Access Compliance Report

Public Rights-of-Way

(Curb Ramps)

Intersection ID: 10733	Main Street: E_34TH_ST	Cross Street: WESLEY_AV	Location: S
ADA ID: 6573EE4B5F3A	Ramp Type: Perpendicular	Initial Pass/Fail: Fail	Overall Compliance: No
Severity Score: 13.75			
Codes/Mitigation Info/Possible Solution		Field Measurements/Component Compliance

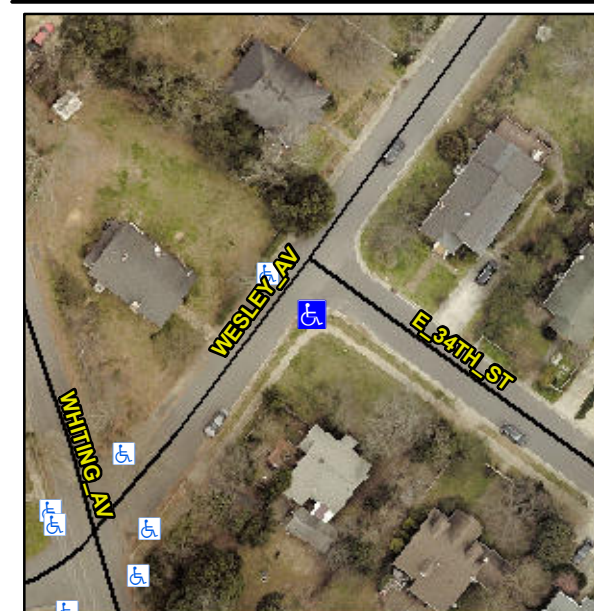
Not Found, R304.2.2, R304.5.3

Compliance	Description	Data	Compliance	Description	Data
N/A	Ramp Length (in)	77.0	No	Ramp Slope (%)	10.6
Yes	Ramp Width (in)	48.0	No	Ramp XSlope (%)	4.2
N/A	Flare Type LT	N/A	N/A	Flare Type RT	N/A
N/A	Flare Slope LT (%)	N/A	N/A	Flare Slope RT (%)	N/A
N/A	Flare Traversable LT?	N/A	N/A	Flare Traversable RT?	N/A
N/A	Landing Length (in)	N/A	N/A	DWS Provided?	N/A
N/A	Landing Width (in)	N/A	N/A	DWS Contrast?	N/A
N/A	Landing Slope (%)	N/A	N/A	DWS Length (in)	N/A
N/A	Landing X Slope (%)	N/A	N/A	DWS Full Width?	N/A
N/A	Landing Curb? (Y/N)	N/A	N/A	DWS Offset (in)	N/A
N/A	Shared Landing?	N/A			
N/A	Gutter Ponding?	N/A	N/A	Gutter Slope (%)	N/A
N/A	Gutter Lip Ht (in)	N/A	N/A	Gutter X Slope (%)	N/A
N/A	Painted X Walk1?	No	N/A	Painted X Walk2?	N/A
	X Walk 1 Direction	To NW		X Walk 2 Direction	N/A
N/A	X Walk 1 Width (in)	N/A	N/A	X Walk 2 Width (in)	N/A
	X Walk 1 Slope (%)	4.5		X Walk 2 Slope (%)	N/A
	X Walk 1 X Slope (%)	1.4		X Walk 2 X Slope (%)	N/A

Remove & Replace Entire Ramp.
